To: T10 Technical Committee
From: Robert Sheffield (Robert.L.Sheffield@intel.com), Intel Corporation
Date: May 5, 2004
Subject: T10/04-030r1, SAS-1.1: Fix SP Hang States

Overview

Figure 72 — SP (phy layer) state machine – SATA Spinup Hold State

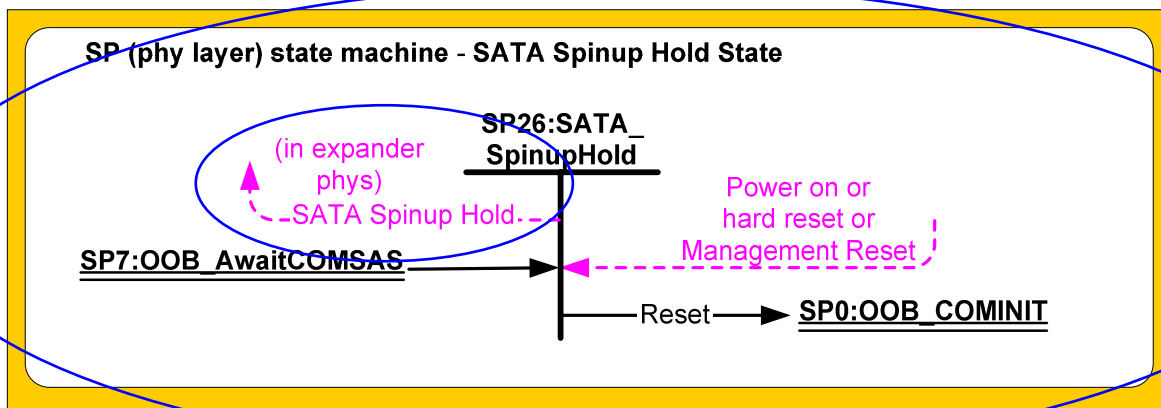
Add subclause 6.7.7 describing the new SATA Spinup Hold state as follows:

Figure 72 shows the SP26:SATA_SpinupHold state. This state shall be entered from the SP7:OOB_AwaitComsas state upon detection of a COMSAS detect timeout if the phy supports SATA, the phy supports Spinup Hold, and the MgmtReset auxiliary state variable has a value of zero. This state shall persist until a Power on, hard reset, or Management Reset occurs. Any such reset shall cause a transition to SP0:OOB_COMINIT.
